TAJ Industries

Fire Safety Inspection Report

Observations & Actions

Pakistan Accord Initial Safety Inspection Report

Figure 2.6 - Insufficient headroom along escape route mezzanine floor record room.

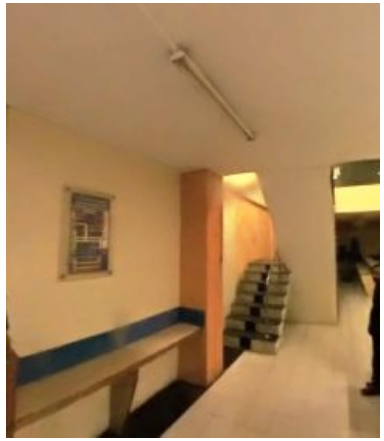
This is not always achieved, examples include (list not exhaustive):
- Trip hazards on escape route e.g. 5th and 4th floor near steam generator area.
- Insufficient headroom along escape route e.g. 1.6 m at mezzanine floor record room.
- Stair discharges inside the building at a distance from building exit e.g. S3, S4 and S5.

Timeline	Remediation Plan
Immediate CAP-0077835	Remove trip hazards on escape routes and keep them clear for escape. Provide warning signs where headroom height is less than 2.05 m on escape routes. Install Smart Padding at locations with headroom clearance below 2.05 m.
Medium Term CAP-0077836	For stairs discharging within the building, prepare drawings showing the proposed fire separating construction to stair discharge corridor leading outside the building. These shall be submitted to the Accord for review and approval prior to the rectification works. The drawings should cover: - Layout showing the location of fire rated walls/doors to protect stair discharge corridors - Details of proposed fire resisting walls and fire door assemblies (e.g. fire door listing, fire rating period, self-closers, door opening direction, details of the door opening mechanism and locks) Propose modifications to ensure 2.05m headroom height is achieved along the escape routes or propose alternative egress routes that comply. Submit the proposal to Pakistan Accord for review.

Longer Term CAP-0077837	Ensure stair discharge routes / corridors are adequately fire separated from the rest of the building or any fire hazards using 2 hours fire separating construction with 90-minute fire doors. The design shall follow the reviewed proposal and comply with Pakistan Accord Standard. Some of the key requirements include: - All doors into stair discharge corridors need to be fire resisting doors (except stair discharge doors to external air). Penetration through the doors is not permitted. All fire doors require self-closers. Doors into stair discharge routes should be kept closed (but not locked) at all times. - All penetrations through walls into stair discharge corridors need to be fire stopped. Unprotected openings (e.g. holes or window/ louver openings) are not permitted. Implement measures to ensure adequate clear head height is achieved along all escape routes.
